Eversource has refused to provide profiles of the X-178 with ACCC type conductor so I have drawn my own for the structures on my property. Eversource needs to provide profiles if it intends to contest this drawing which shows that structure heights could be lowered by 25'-30' or more while conforming to Code. Conductor is Southwire Gannet.

kris pastoriza
 1/23/2025
 SEC 2024-02
 DE-24-087
 VT 24-3579-PET

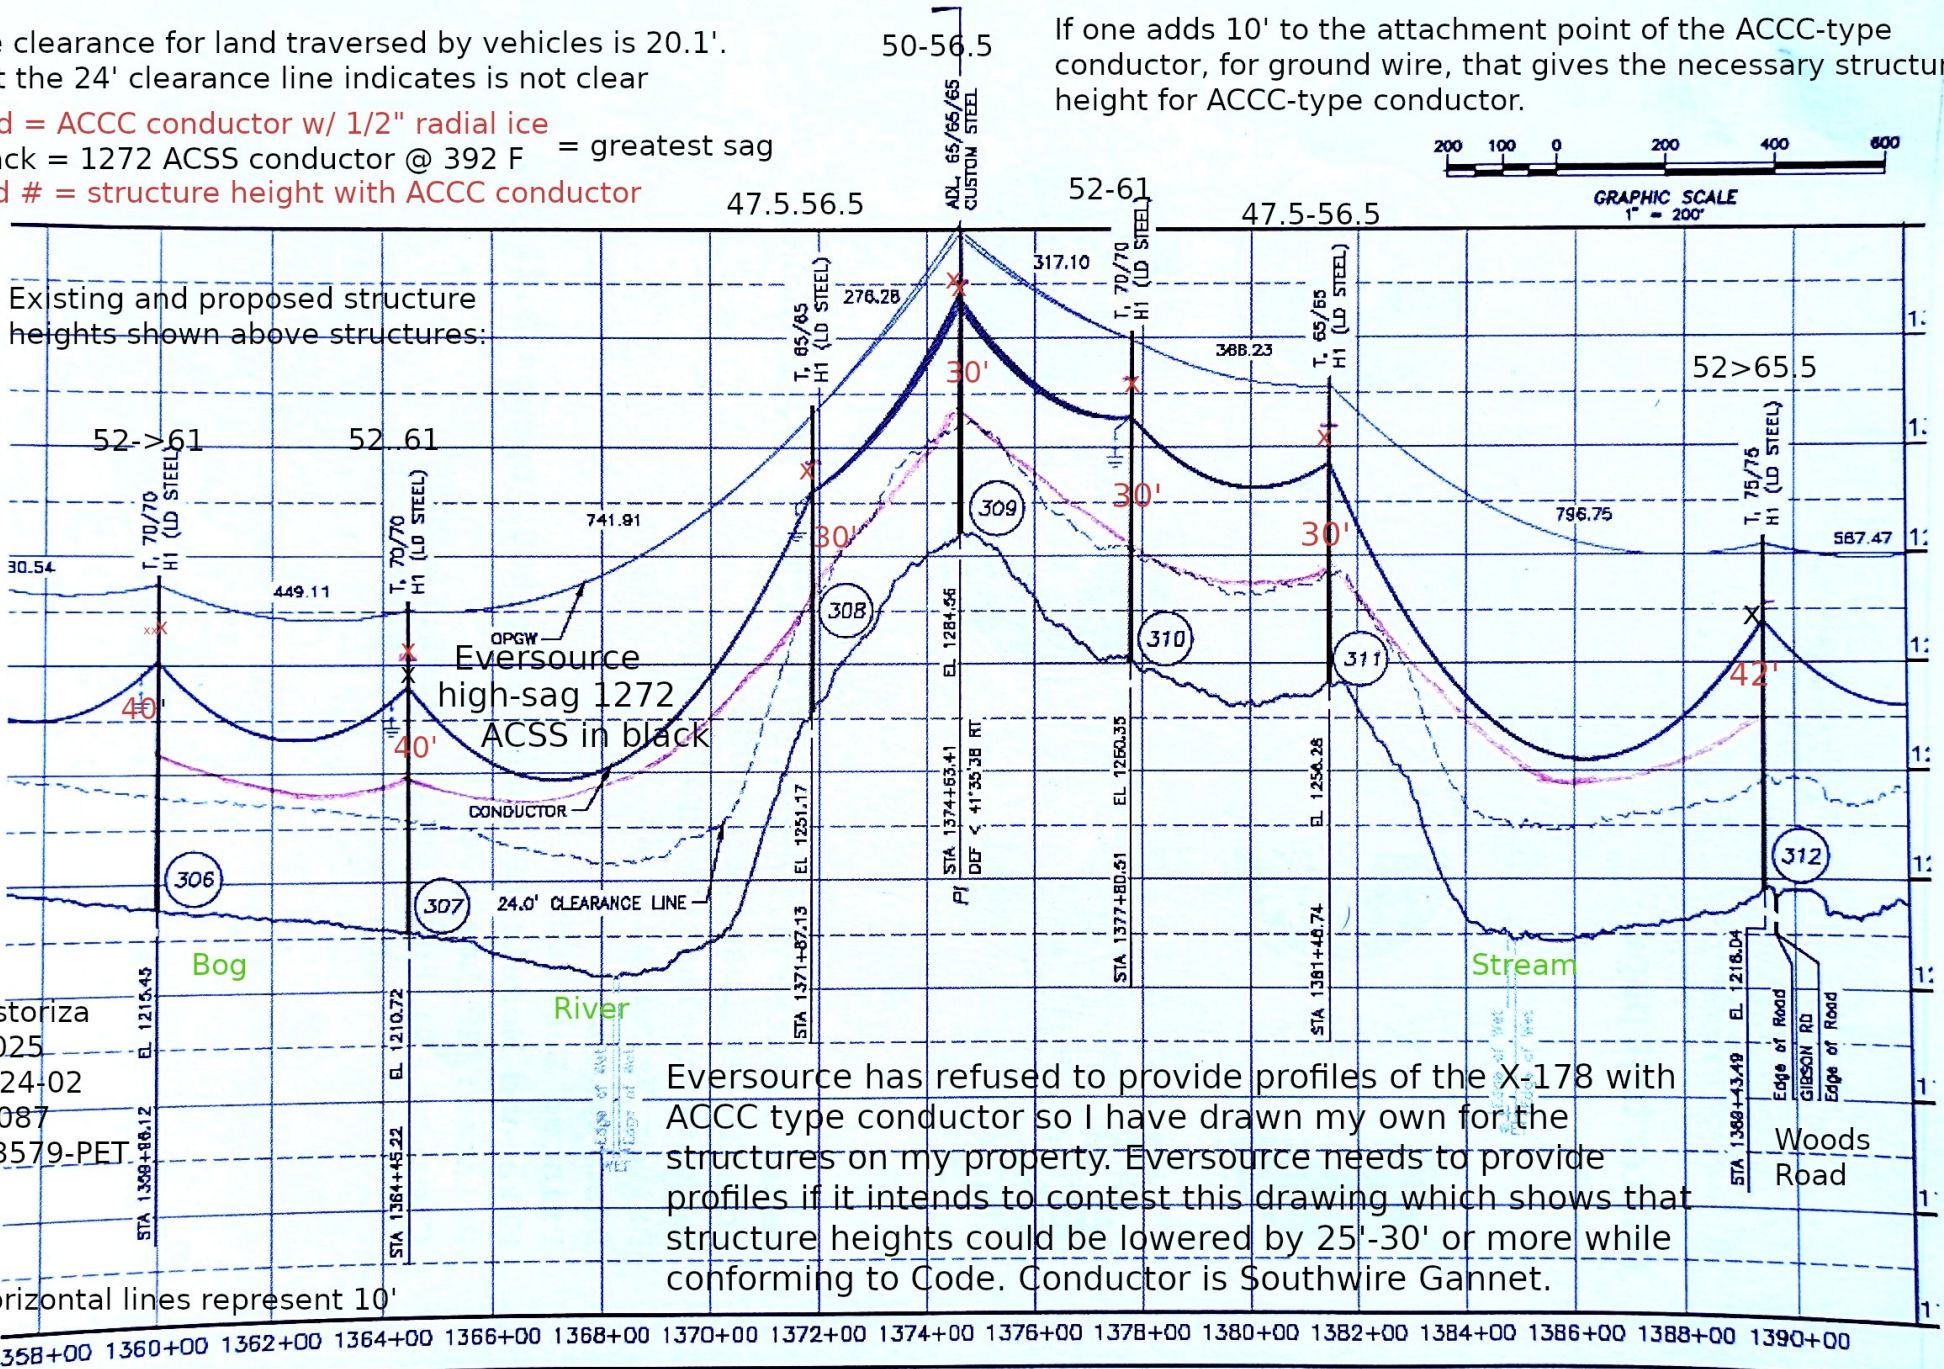
Code clearance for land traversed by vehicles is 20.1'.
 What the 24' clearance line indicates is not clear

If one adds 10' to the attachment point of the ACCC-type conductor, for ground wire, that gives the necessary structure height for ACCC-type conductor.

The SEC and PUC need the profiles for ACCC-type conductors of various amperages at minimum clearances.
